A d d e n d u m

Iowa Department of Transportation
Office of Contracts

B.O.	Proposal ID	Proposal Work Type	County	Project Number	Addendum
501	57-1001-081	CLEARING & GRUBBING	LINN	NHSN-100-1(81)--2R-57	19NOV501.A01

TREE FELLING
NHSN-100-1(81)-2R-57

ENGLISH	IOWA DOT	DESIGN TEAM	Iowa DOT\CH2MHILL	LINN COUNTY	PROJECT NUMBER	NHSN-100-1(81)-2R-57	SHEET NUMBER	D.8
2013\11\01	Jwan		cr:\pwworking\dot\ch2mhill\tbg\jwan\dot\79931\57\0008\001.sht

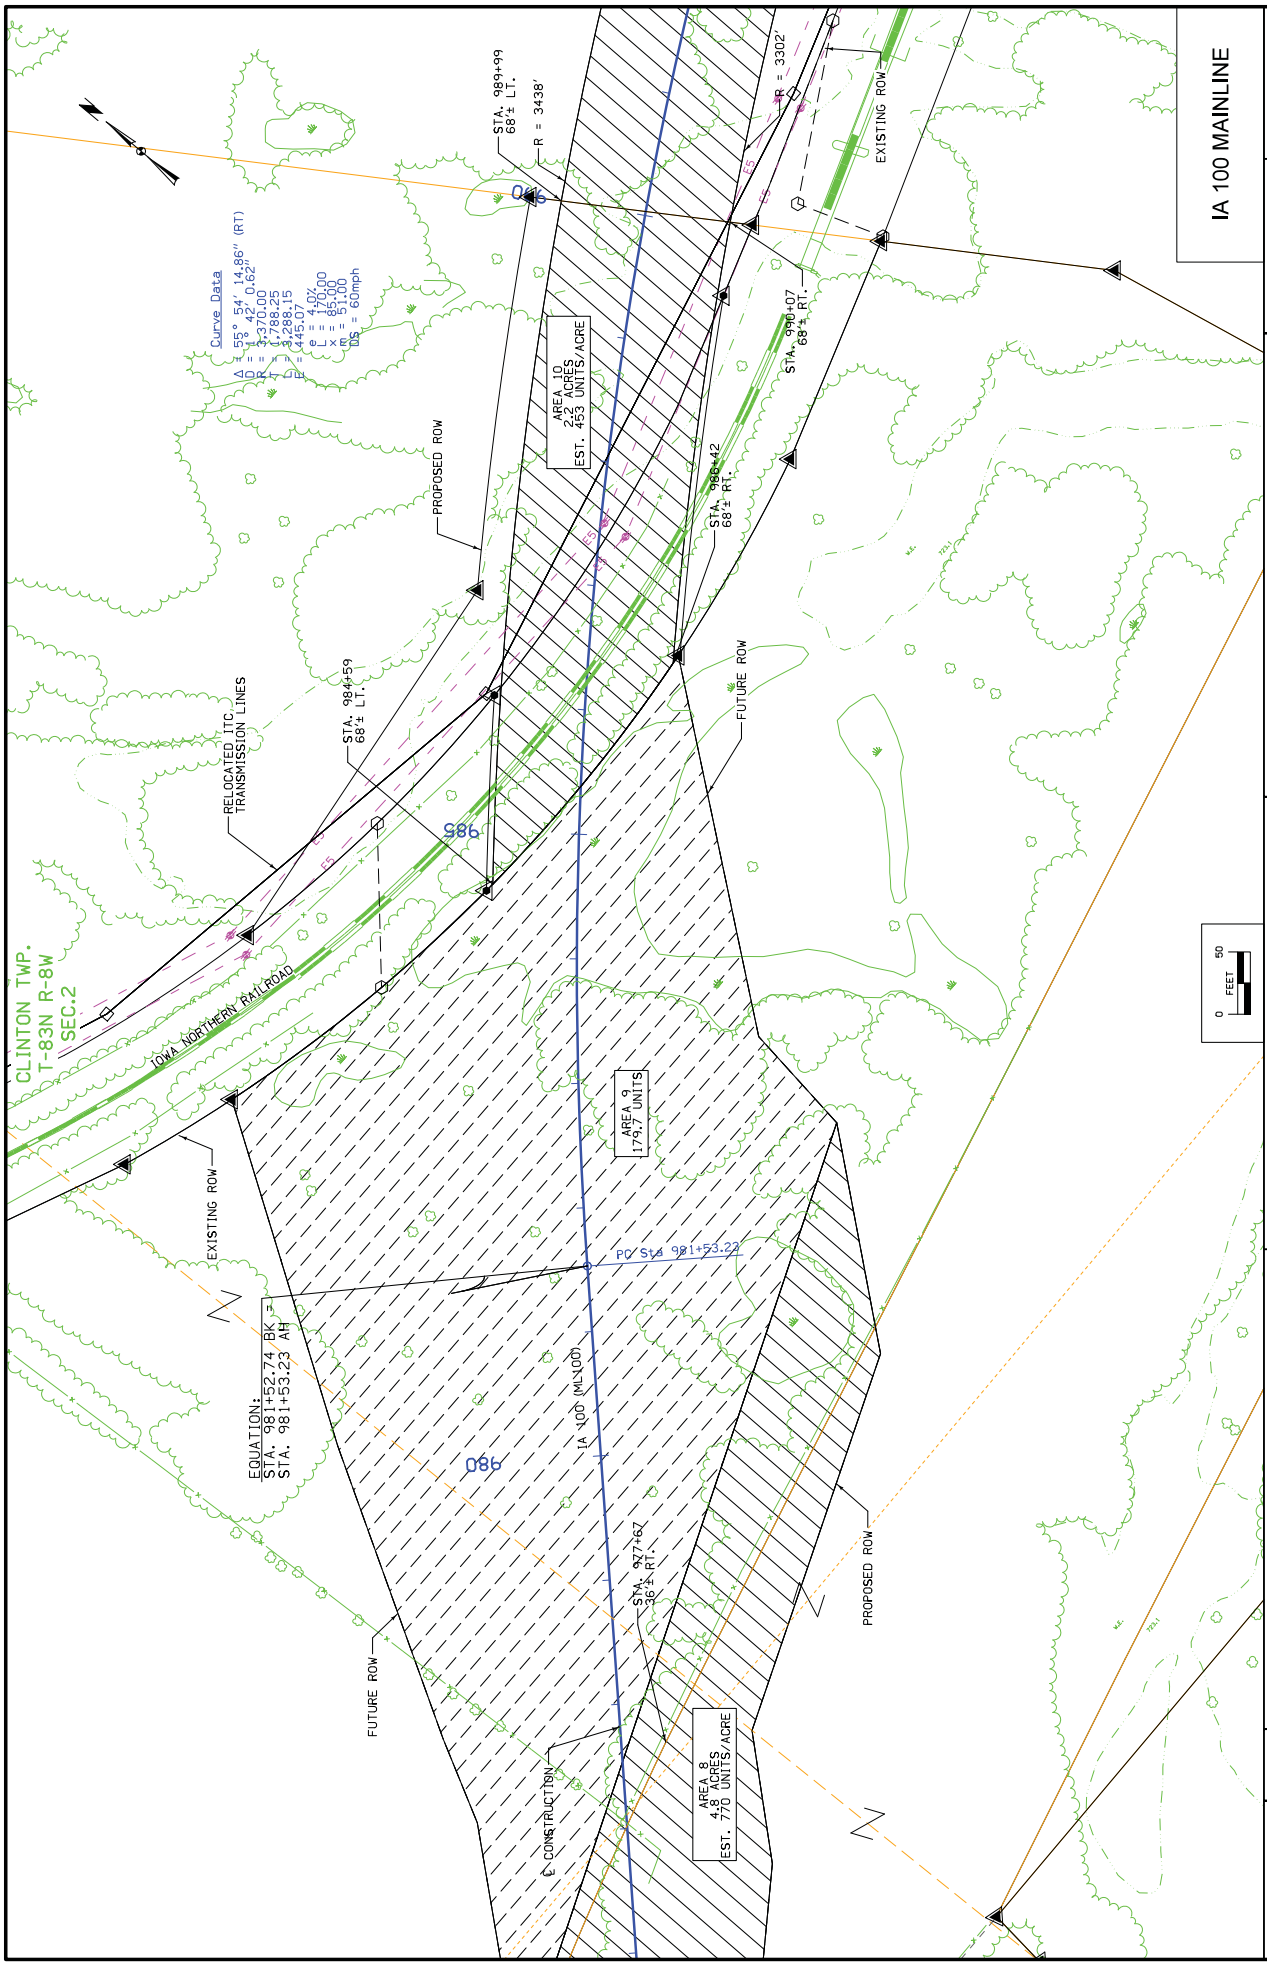
Replace Sheet D.8 with the attached Sheet D.8.
Updated Area 8 limits, quantity note, and associated callouts
Added Area 9 limits, quantity note, and associated callouts
Added Area 10 limits, quantity note, and associated callouts

ENGLISH	IOWA DOT	DESIGN TEAM	Iowa DOT	CH2MHILL	PROJECT NUMBER	NHSN-100-1(81)-2R-57	SHEET NUMBER	D.9
2013\11\01	Jwan				LINN COUNTY			
1:35:17 PM

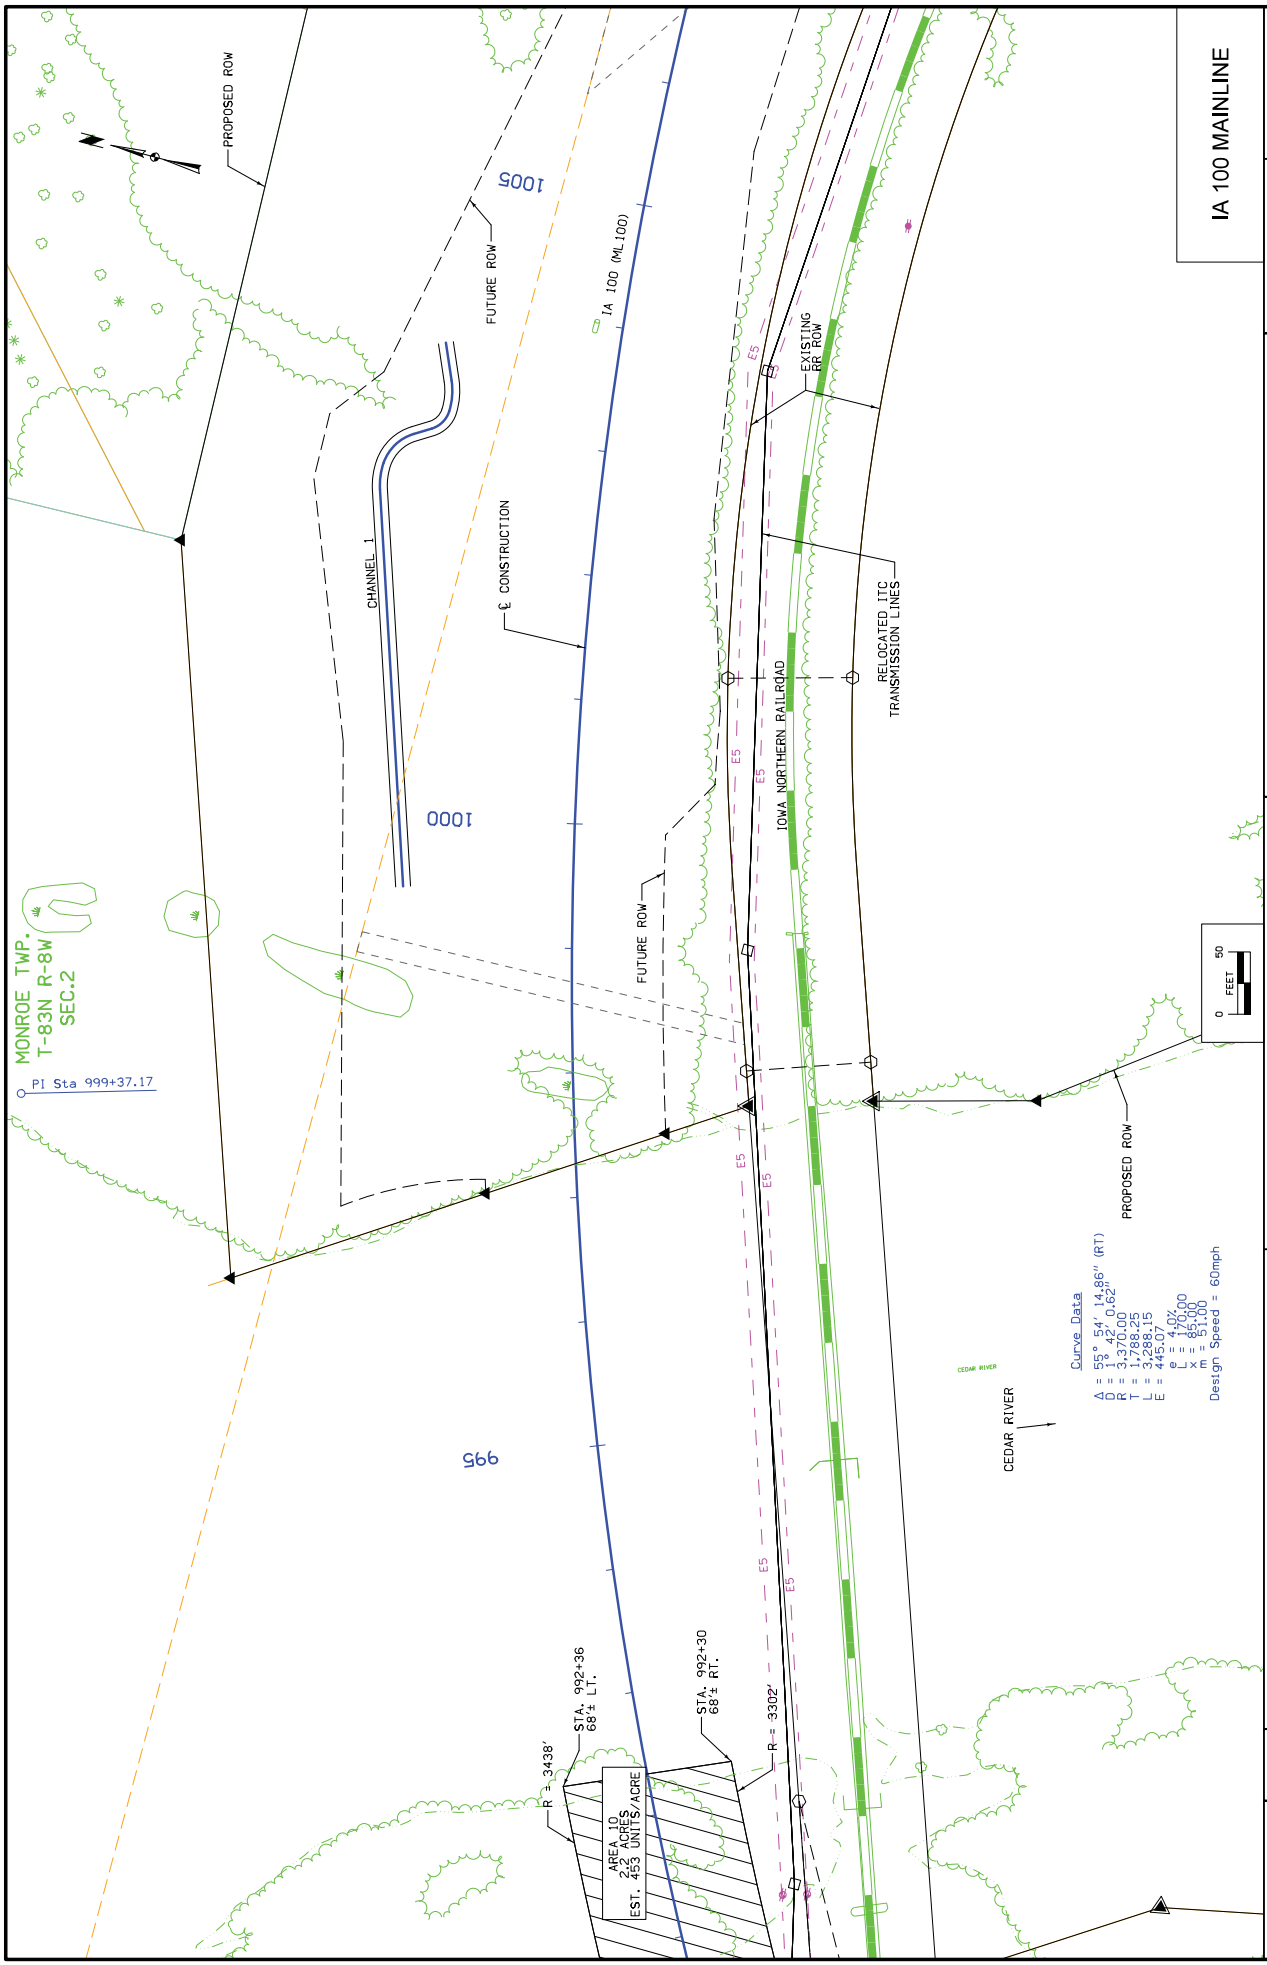
Replace Sheet D.9 with the attached Sheet D.9.
Added Area 10 limits, quantity note, and associated callouts

ENGLISH	DATE	DESIGN TEAM	Iowa DOT\CH2MHILL	LINN COUNTY	PROJECT NUMBER	NHSN-100-1(81)-2R-57	SHEET NUMBER	D.14
2013/11/01	Jwan		cr:\pwworking\ch2mhill\tbg\jwan\dot179931\57\0008\001.sht

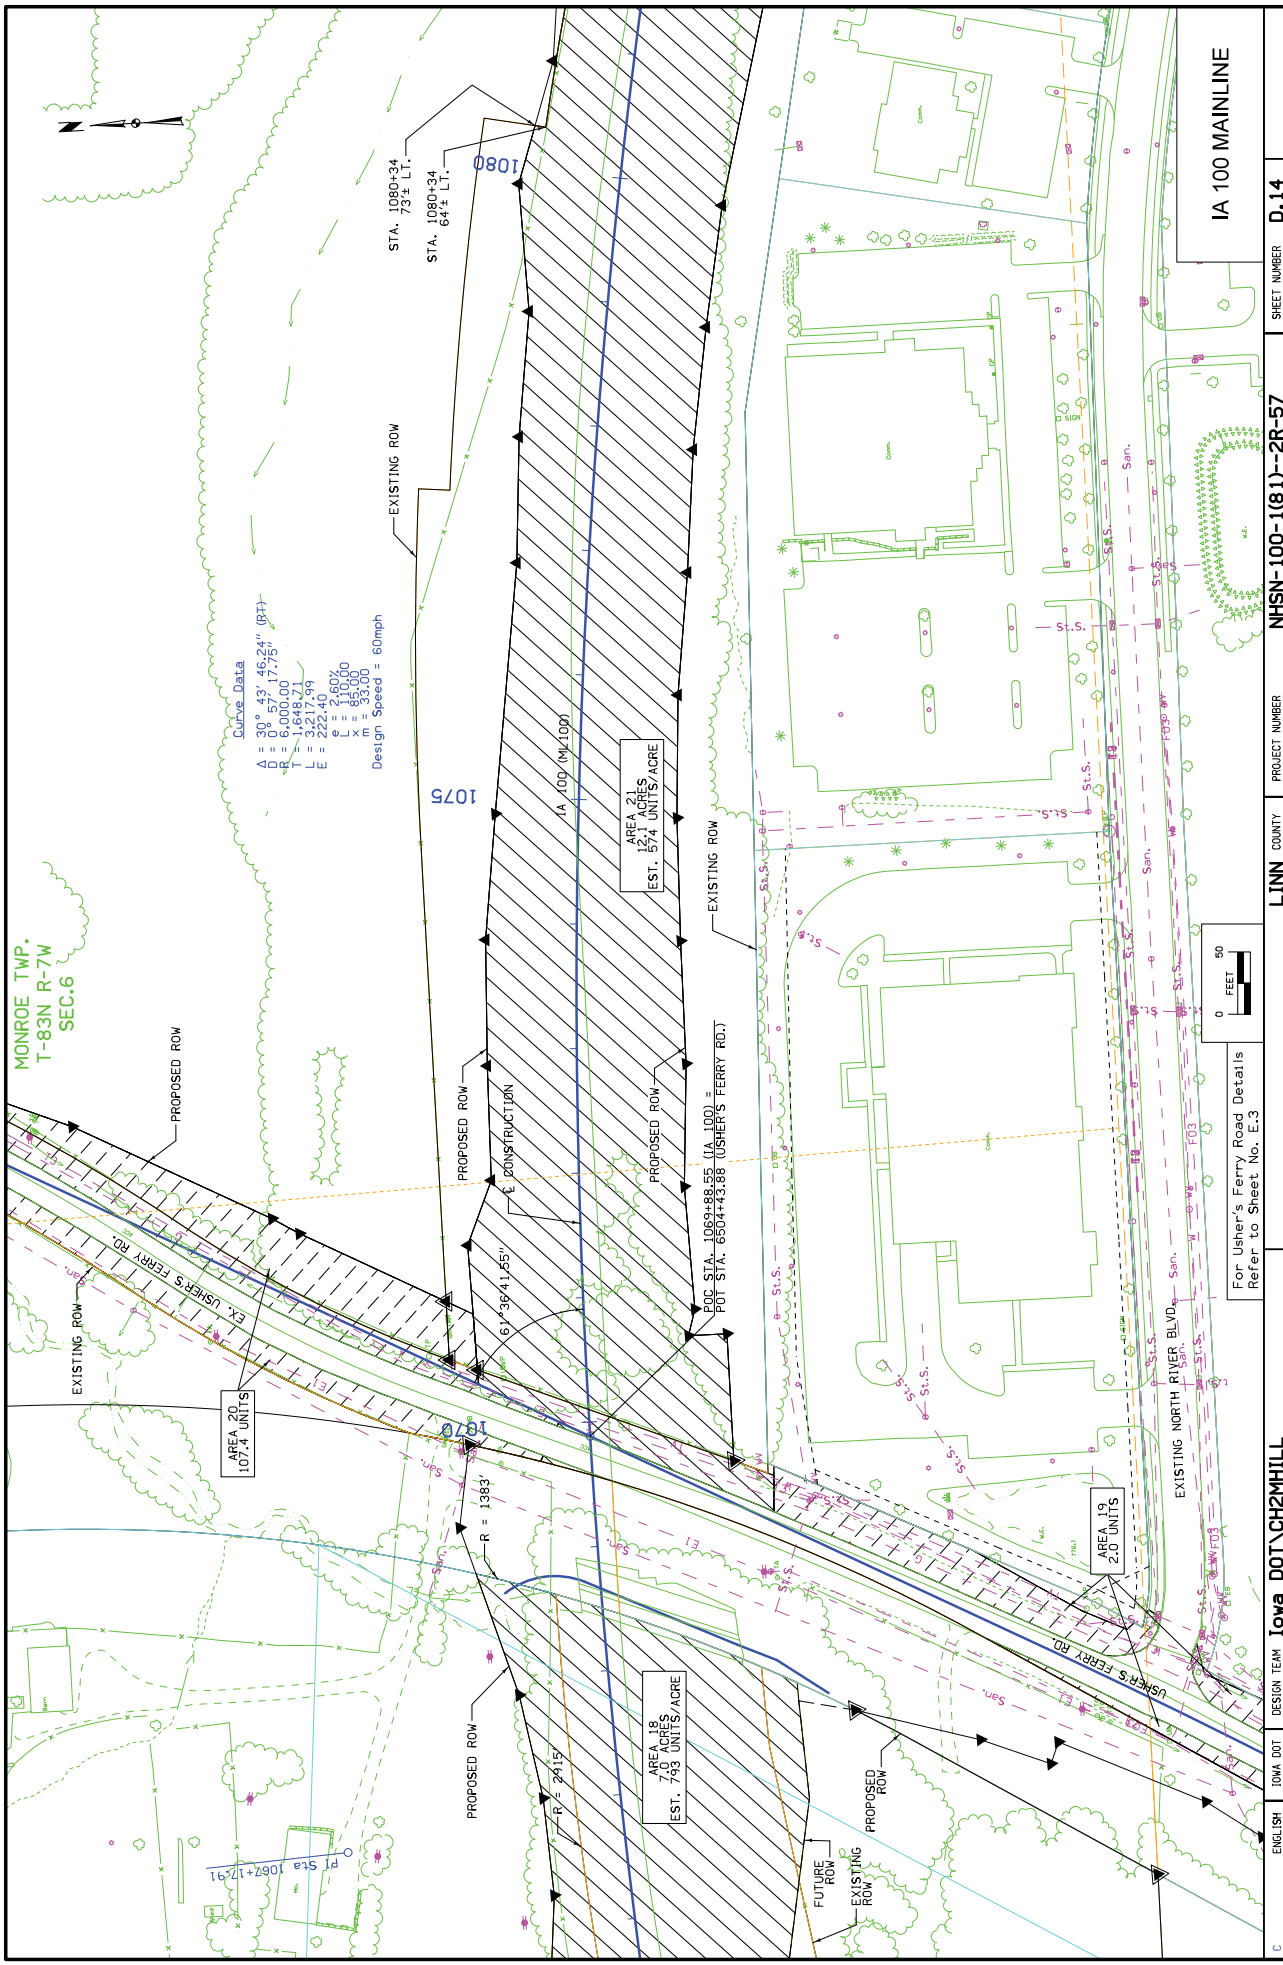
Sheet D.14 with the attached Sheet D.7.
Updated Area 21 note

Replace Sheet D.14 with the attached Sheet D.7.
Updated Area 21 limits, quantity note, and associated callouts
Updated Area 23 limits

1:35:21 PM	ENGLISH	2013\11\01	Jwanli	DESIGN TEAM	Iowa DOT\CH2MHILL	PROJECT NUMBER	NHSN-100-1(81)-2R-57	SHEET NUMBER	D.15
IA 100 MAINLINE

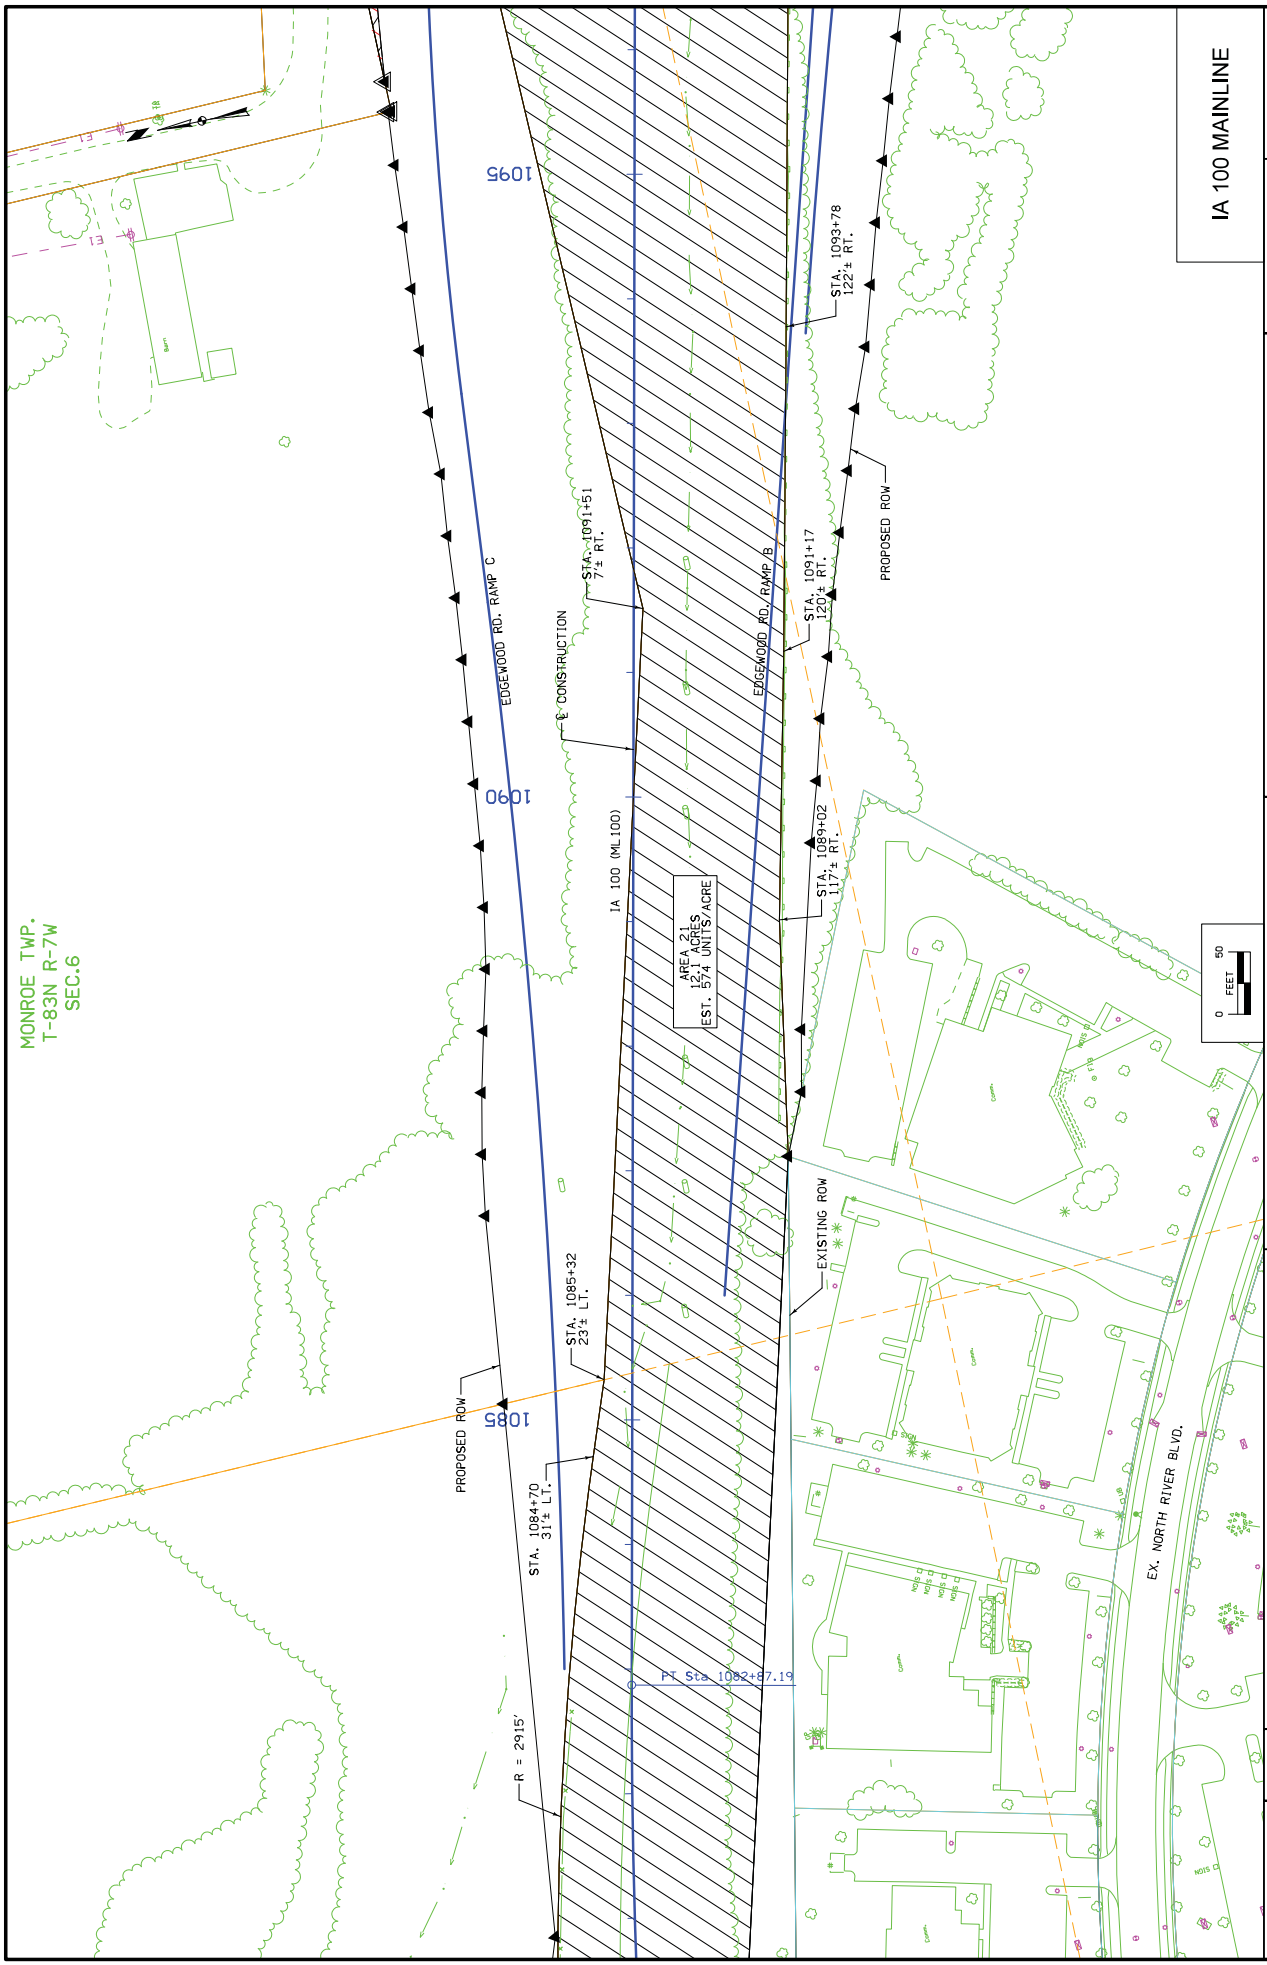
Replace Sheet D.15 with the attached Sheet D.7.
Updated Area 21 note
